Metropolitan Development Commission Regional Center Hearing Examiner (September 11, 2025) Meeting Agenda

STAFF REPORT

Case Number	2025-REG-033
Address (approx.)	2955 North Meridian Street
Location	Center Township, Council District #12
Petitioner	2955 Indy IN, LLC, by Michael Rabinowitch
Zoning	C-S (TOD) (RC)
Request	Regional Center Approval for provide for a mixed-use development consisting of a dance studio, commercial retail, and residential uses, including townhomes and multi-family dwellings.

Site Plan

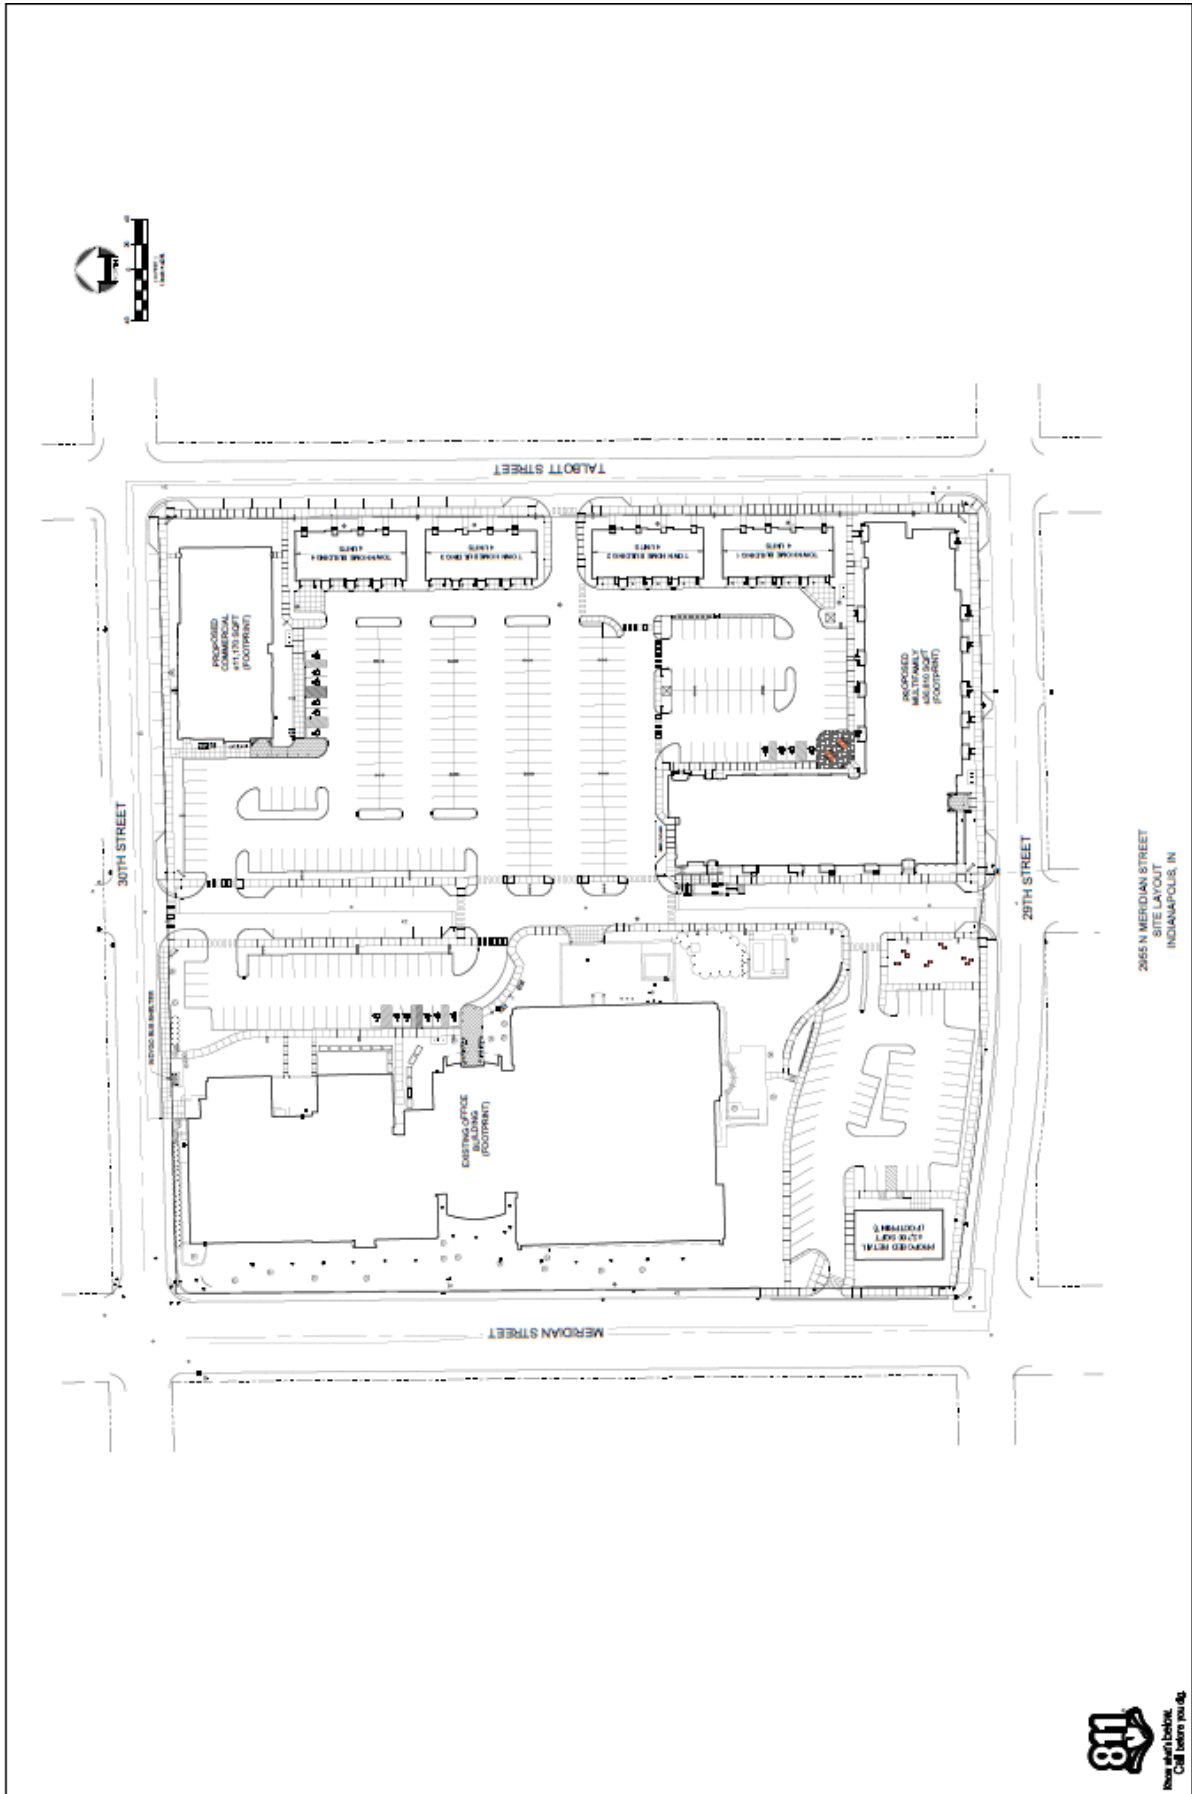
2. The submittal did not include a detailed landscape plan, with plant species. A detailed landscape plan shall be submitted for staff review and approval prior to issuance an Improvement Location Permit, in accordance with Guidelines US 1.3.2, CA 4.6.1, CA 4.6.2, CA 4.6.3, CA 4.6.4, and CA 4.6.5.

4. No details were submitted for outdoor recreational areas or bicycle parking for residents, as required per Guidelines SC 1.4.1 and CA 4.2.4 apply. Details of outdoor recreational areas and resident bicycle parking shall be submitted and subject to planning staff review and approval prior to issuance of an Improvement Location Permit.

5. A lighting plan was not submitted to the file to identify the location of lighting standards or fixtures. Additionally, a photometric plan has not been submitted to the file. A photometric plan should detail light standards and photometric levels for the site and at each entrance. Lighting must be provided at each entrance and must be dusk to dawn. Only full cut and shielded light standards are permitted with minimum foot-candle power outlined in CA 4.3.2 and CA 4.3.3. Pedestrian areas and entries must be lighted for safety (CA 3.1.3 and CA 4.3.1). A lighting plan should be submitted prior to the hearing to ensure compliance with these requirements. If such a plan is not available, a detailed lighting plan shall be submitted and subject to planning staff review and approval prior to issuance of an Improvement Location Permit.

North elevation – dance studio – revised

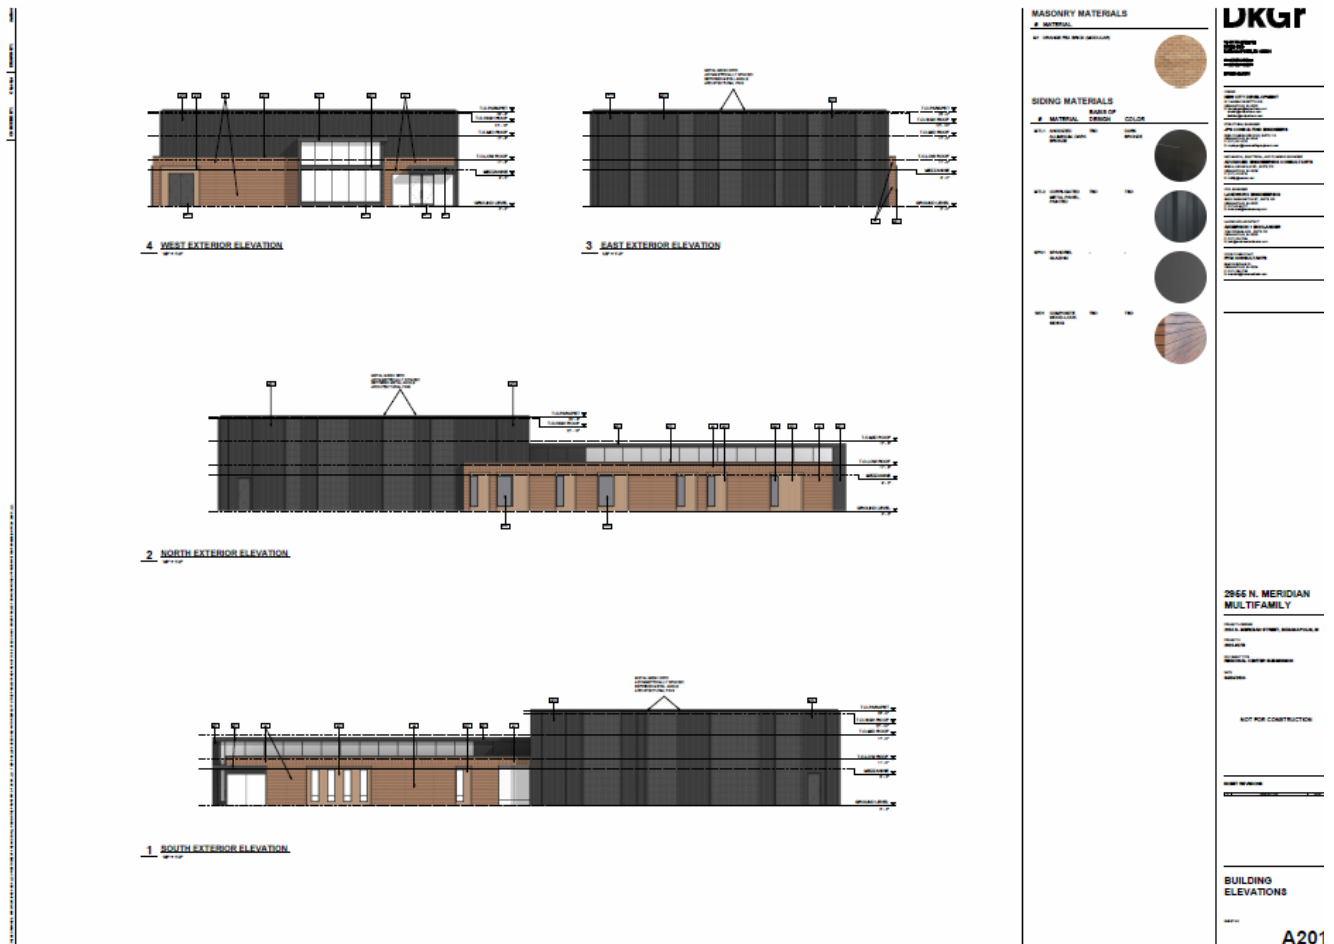
Proposed elevations for the dance studio. Note: the north elevation has been revised, see above.
